# HISTORIC AND DESIGN REVIEW COMMISSION

March 03, 2021

**HDRC CASE NO:** 2021-027  
**ADDRESS:** 520 LEIGH ST  
**LEGAL DESCRIPTION:** NCB 2739 BLK LOT 4F & PT OF 5F (AKA TRACT 6)  
**ZONING:** IDZ,H  
**CITY COUNCIL DIST.:** 1  
**DISTRICT:** Lavaca Historic District  
**APPLICANT:** LABOR STREET COMMONS LLC  
**OWNER:** LABOR STREET COMMONS LLC  
**TYPE OF WORK:** Construction of a 2-story residential structure, site modifications  
**APPLICATION RECEIVED:** January 15, 2021  
**60-DAY REVIEW:** Not applicable due to City Council Emergency Orders  
**CASE MANAGER:** Stephanie Phillips

The applicant is requesting final approval to construct a new 2-story single family residence at the lot addressed 520 Leigh St. Some of the schematic documents include conceptual information about a new 3-story multifamily residential structure in the center-rear of the lot addressed 606-608 Labor St, as well as renovation work and rear additions to three 1-story historic structures on the same parcel, two of which are located along the Labor St frontage. These scopes are not included in the current request.

1 **Standalone Residence-West Elevation**  
3/16" = 1'-0"

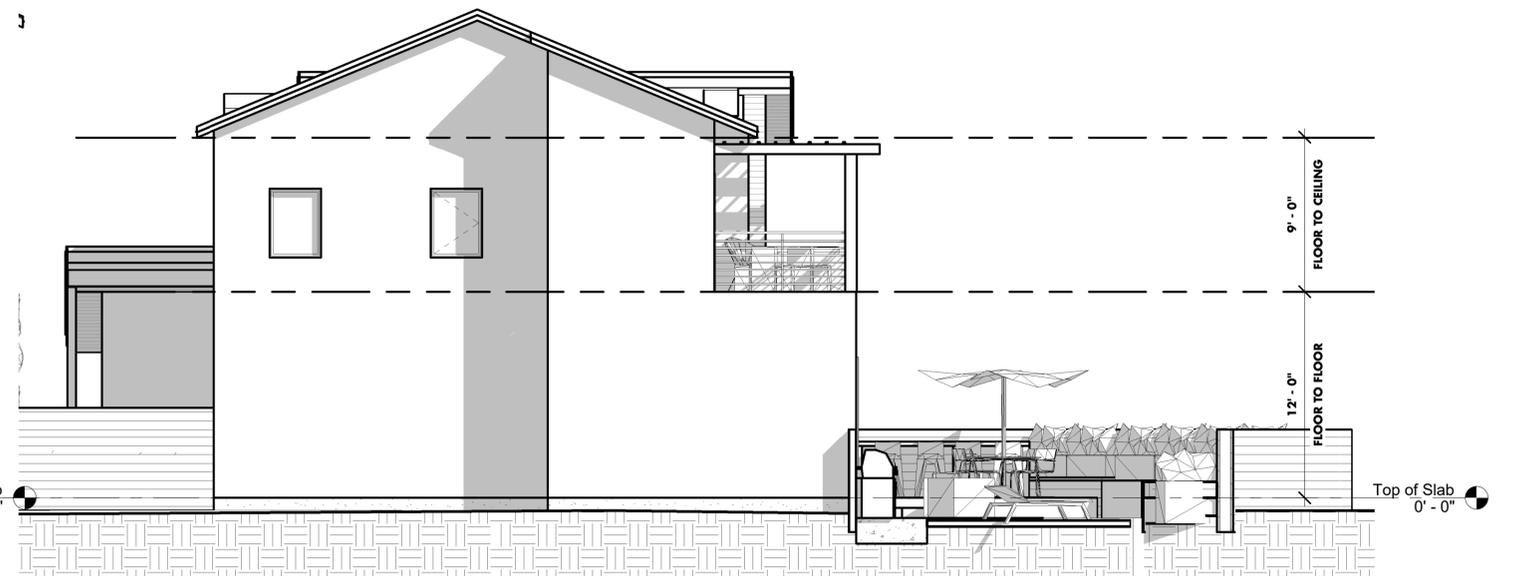
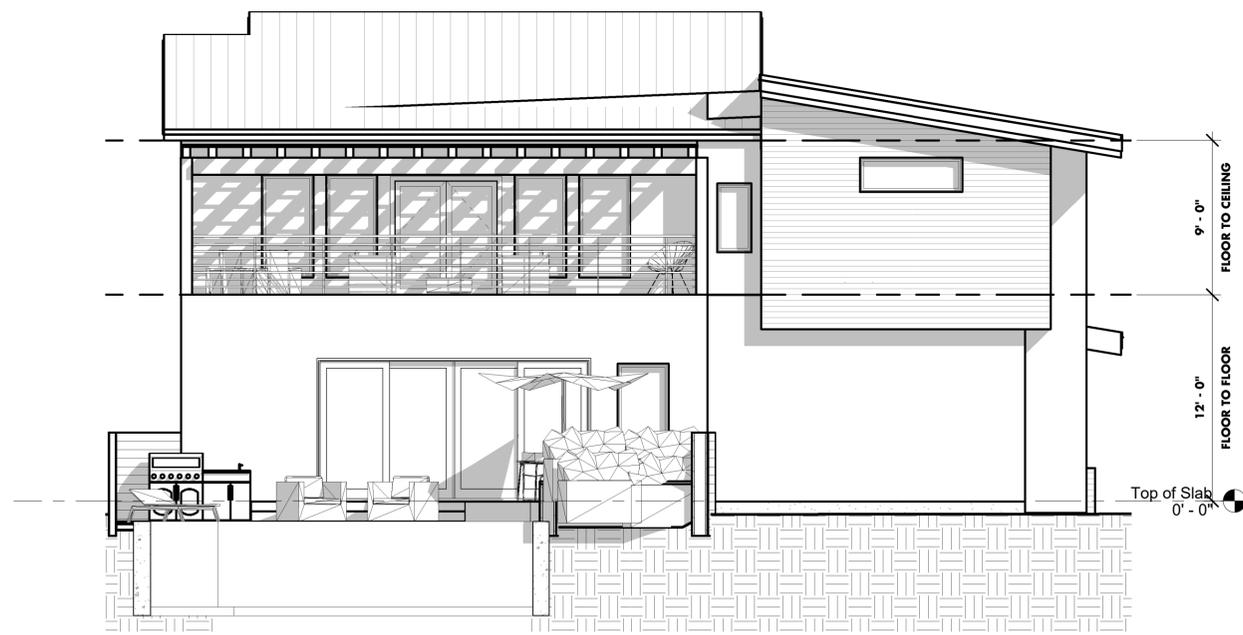
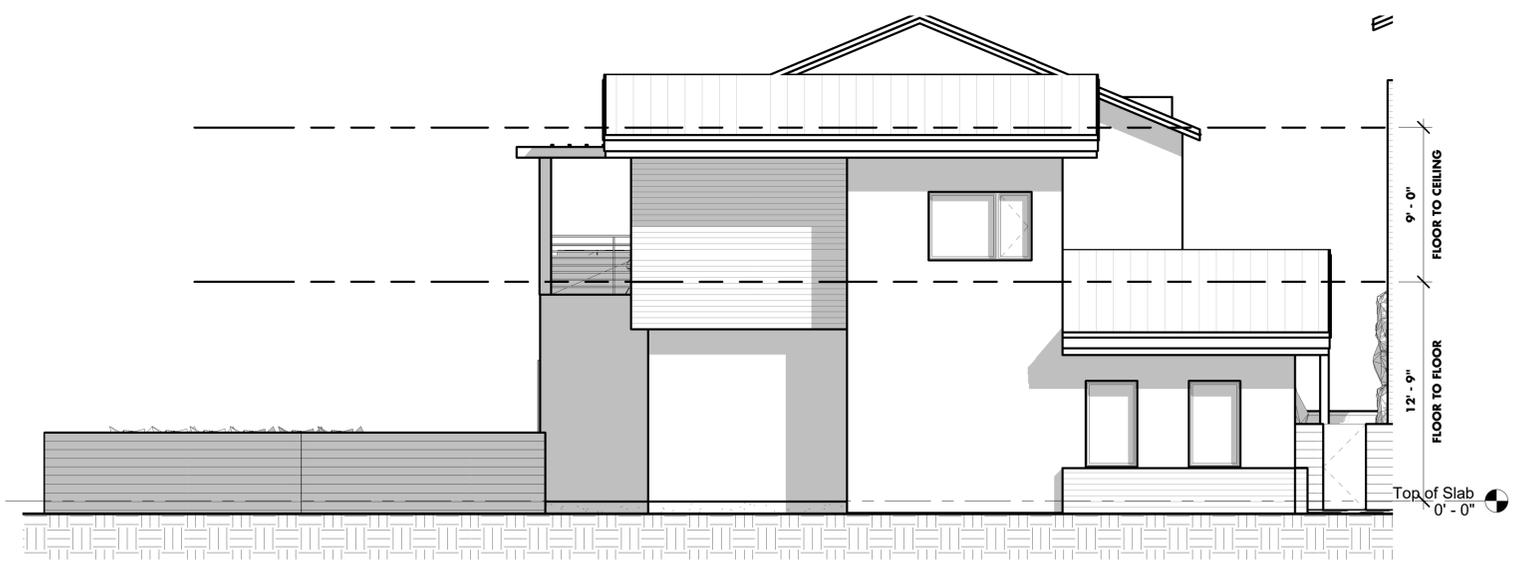
- i. **FOUNDATION & FLOOR HEIGHTS** – Per the Guidelines for New Construction 2.A.iii., applicants should align foundation and floor-to-floor heights within one foot of floor-to-floor heights on adjacent historic structures. Based on the submitted elevations, the proposed foundation is slab-on-grade with a minimal rise. Staff finds that the applicant should utilize foundation heights that are consistent with the Guidelines.

- j. **ROOF FORMS** – The applicant has proposed a multi-slope roofline. The primary roofline is a side gable with a low-sloping shed roof extending to the north. Staff generally finds these roof forms to be consistent based on the surrounding context, but finds that in context with the proportions of the home, additional roof solutions should be explored to visually reduce the mass of the flat roof portion, primarily on the north and east elevations.

- k. **WINDOW & DOOR OPENINGS** – Per the Guidelines for New Construction 2.C.i., window and door openings with similar proportions of wall to window space as typical with nearby historic facades should be incorporated into new construction. Per the elevations that the applicant has submitted, staff finds the proposed windows to be inconsistent with the Guidelines. The proposed sizes, configurations, and rhythm are not found historically within the district.

- l. **PORCH MASSING** – The applicant has proposed a front porch that consists of a stoop and roof element that is attached to the front façade of the historic structure. Porches found historically within the district feature massing that is incorporated into the massing of the structure, rather than simply attaching to the front façade, particularly in the case of two story structures. Staff finds that the proposed porch massing should be incorporated into the overall design of the structure and feature porch configurations and details that are historically found in the district.

- iii. That the applicant utilize foundation heights that are consistent with the Guidelines, as noted in finding i.
- iv. That the applicant incorporate roof forms that are more consistent with the surrounding historic context as noted in finding j.

- v. That the applicant incorporate appropriate window sizes and proportions and modify the overall fenestration pattern as noted in finding k.
- vi. That the applicant incorporate appropriate front porch massing as noted in finding l.

**Rendering looking directly at 522 Leigh Street**

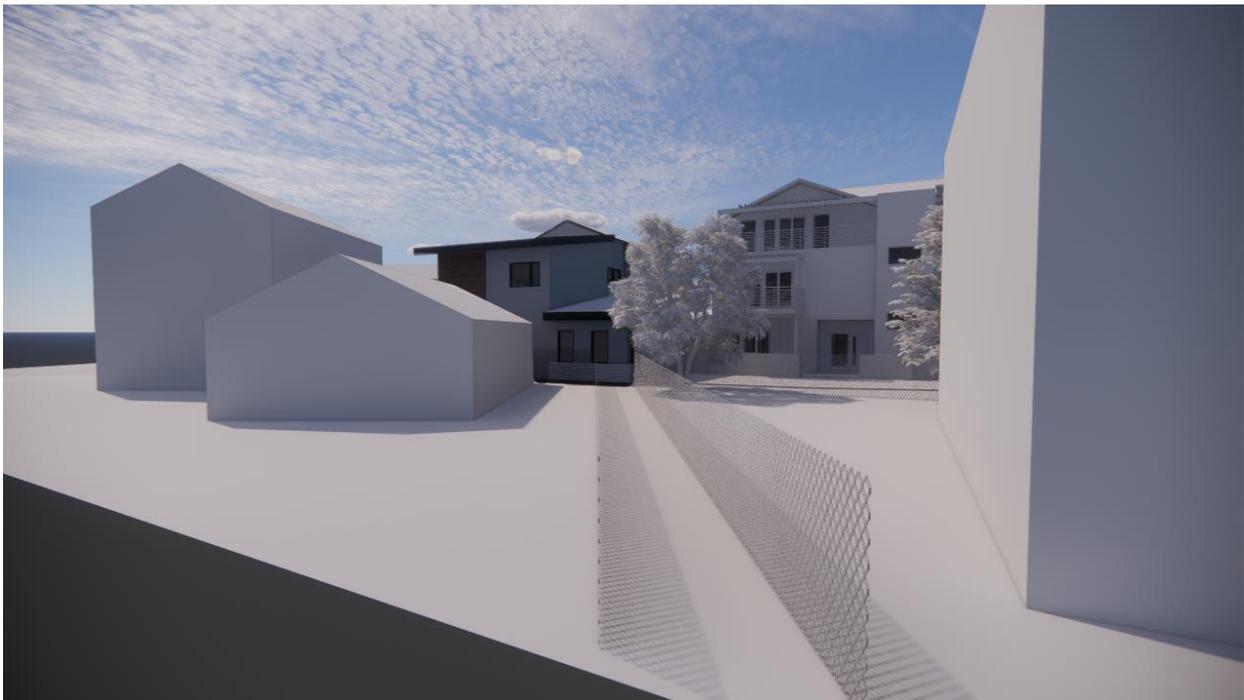
**STAFF NOTE: THREE STORY  
STRUCTURE IS NOT EXISTING AND  
HAS NOT BEEN REVIEWED OR  
APPROVED BY OHP OR HDRC**

**Rendering looking down 6' walkway from Leigh Street**

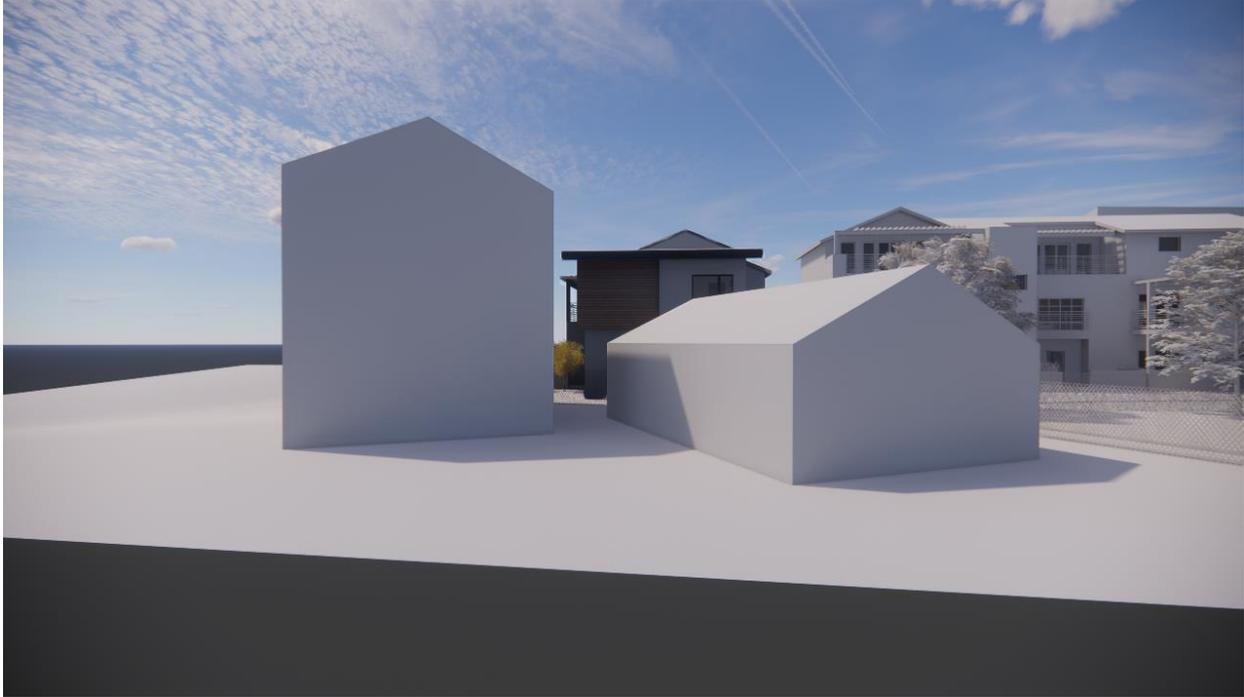
**STAFF NOTE: THREE STORY  
STRUCTURE IS NOT EXISTING AND  
HAS NOT BEEN REVIEWED OR  
APPROVED BY OHP OR HDRC**

**Rendering looking Northeast from Labor Street**

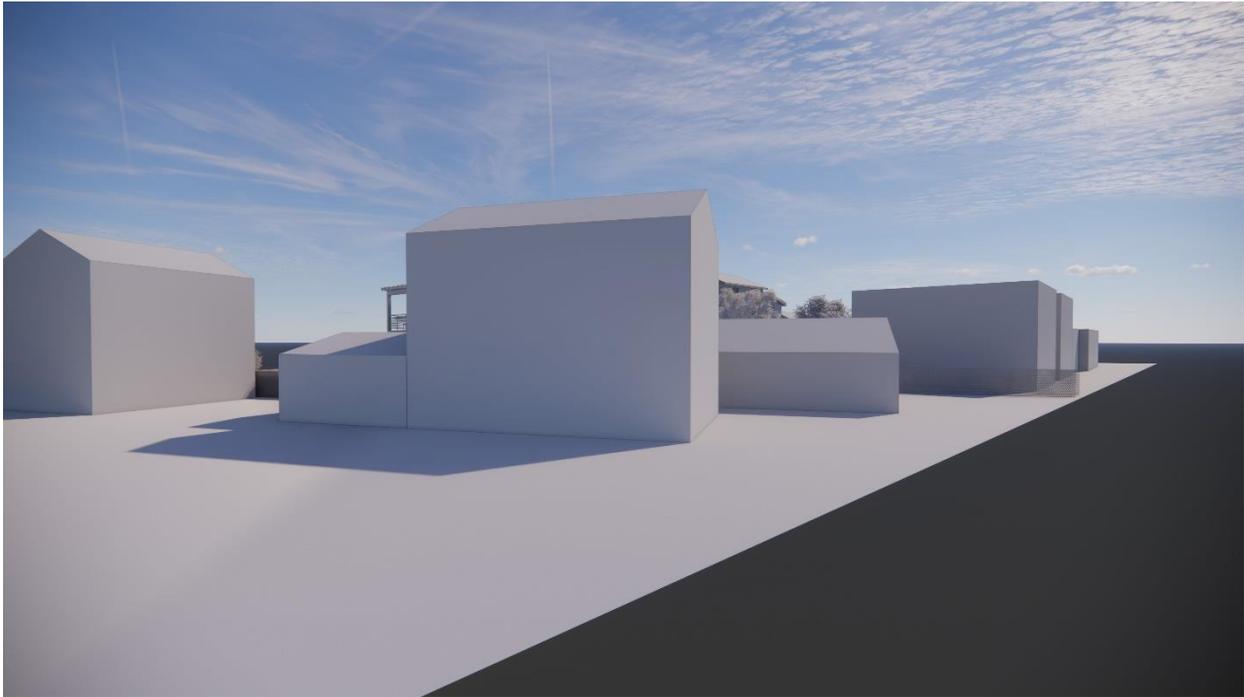
**STAFF NOTE: THE 2-STORY REAR ADDITIONS  
REPRESENTED ON THESE 1-STORY HISTORIC  
STRUCTRES ARE NOT EXISTING AND HAVE NOT  
BEEN REVIEWED OR APPROVED BY OHP OR HDRC**
